## **ADDENDUM TO THE CONTRACT**

### **VISITOR'S INFORMATION KIOSK REPLACEMENT Contract No. DH19-039**

**ADDENDUM NO.: THREE**

② TYPICAL WALL/FOOTING

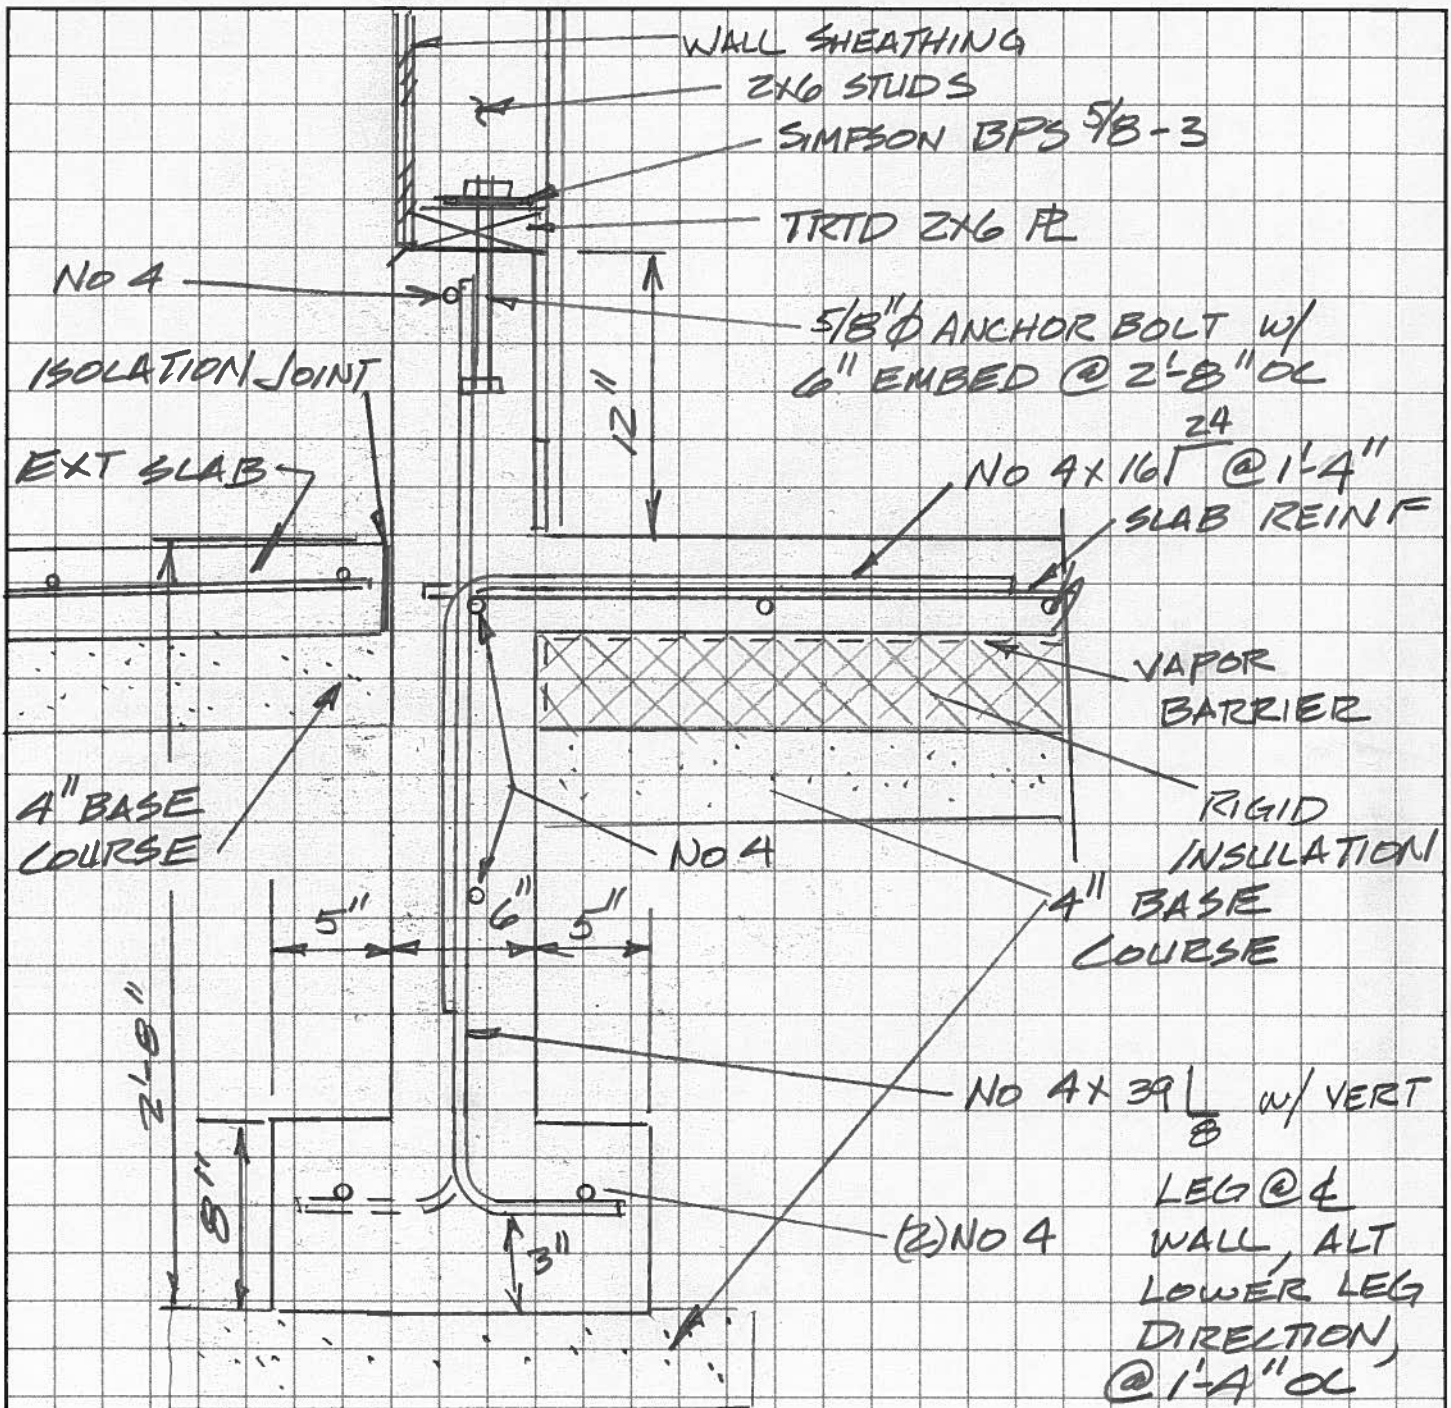
- Item No. 3 SHEET A802 - Drawing 4/A802 – TOWER CORNER, **modify** corner trim callout to read: "EPS-OC075-SQ".
- Item No. 4 SHEET S200 - See attached detail to **revise** detail 2/S200 – TYPICAL WALL/FOOTING.
